Appendix A

NOP and Scoping Comments

Fenton Parkway Bridge Project

Subject: Joint Response to the Notice of Preparation of an Initial Study and Draft
Environmental Impact Report for the Fenton Parkway Bridge Project
(SCH#2023050534)

Flooding

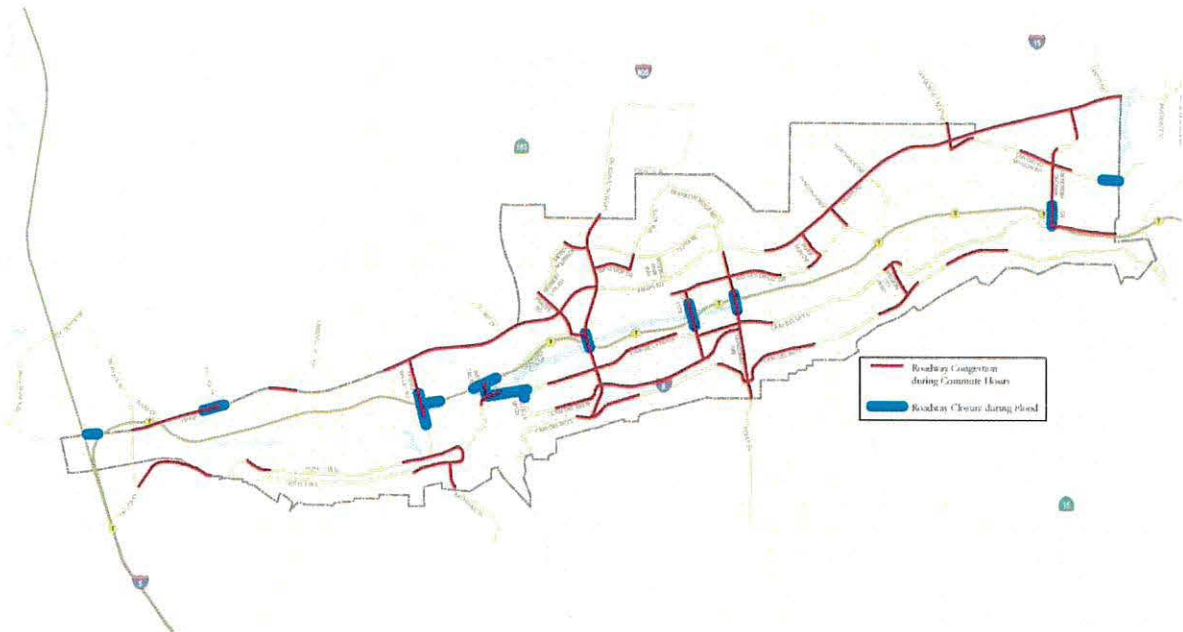
During recurring flooding events in Mission Valley, every street crossing the San Diego River (seven) and some roadways adjacent to the River (three) become impassable.

The only way to travel across the San Diego River on the east side of Mission Valley during these events is via I-15. Since pedestrians and cyclists cannot use the freeway, they are unable to cross the river during flooding events. The Fenton Parkway extension will remedy this issue providing a high-water crossing of the San Diego River that also provides access to the Green Line Trolley and SDSU Mission Valley Campus from the Mid City communities via the SR 15 Bike Path.

Source: Excerpt from Map 3b. Standards of Response Cover Review: Volume 3 Map Atlas, San Diego Fire-Rescue Department & Citygate Associates, LLC, 2017

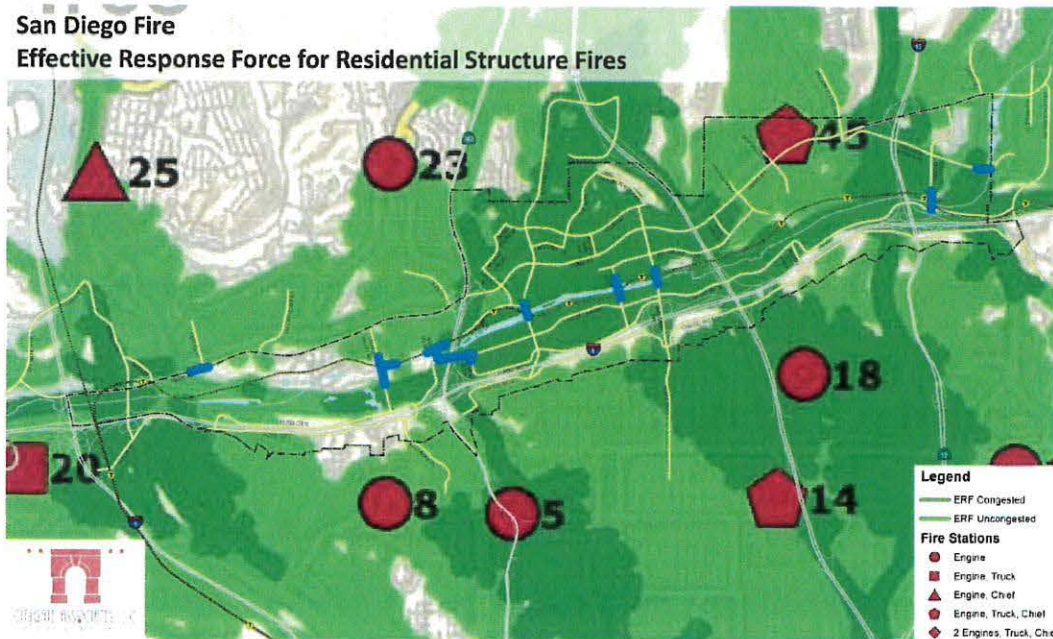
While the [Citygate Report](#) (2017) does not specifically call out any gaps in Mission Valley in their analysis, the [Map Atlas](#) still shows gaps in coverage within Mission Valley. Specifically, in Map 3b “5 Minute Engine Travel Congested and Uncongested”, there is an apparent gap around the Riverwalk Golf Course as shown in the inserted map below. In addition, Map 5b from Map Atlas pg. 21 inserted below “Effective Response Force (ERF) For Residential Structure Fires Congested and Uncongested” shows gaps at the Riverwalk Golf Course and along the south side of Mission Valley with much of eastern Mission Valley not experiencing coverage in congested conditions. Since the 2017 Citygate study, development has increased to include SDSU Mission Valley. Additionally, planned development in the Mission Valley area will continue to increase traffic congestion.

ADUs will increase the need for ingress and egress options during emergencies due to any additional population density. This will improve the need for access to transportation hubs as Mission Valley Community Plan area accommodates planned housing needs. The Fenton Parkway Bridge connection would provide improved police, fire-rescue, lifeguard/swift-water rescue, ambulance emergency response times, and improved emergency transport times to hospitals. Mobility connection in the location would reduce the risk that an area of the community will become inaccessible if all or a part of a roadway is blocked and improve access to UCSD Hillcrest Medical Center. Additionally, the bridge connection location would improve the ability for fire stations to serve a greater area when multiple stations are responding to incidents and/or covering adjacent districts. The bridge connection location would provide multiple approach route options for emergency response and alternate routes for diverting traffic during emergencies that close road(s). This planned connection is particularly important because there are often multiple responders to an incident who need access from different directions to the area and stage.
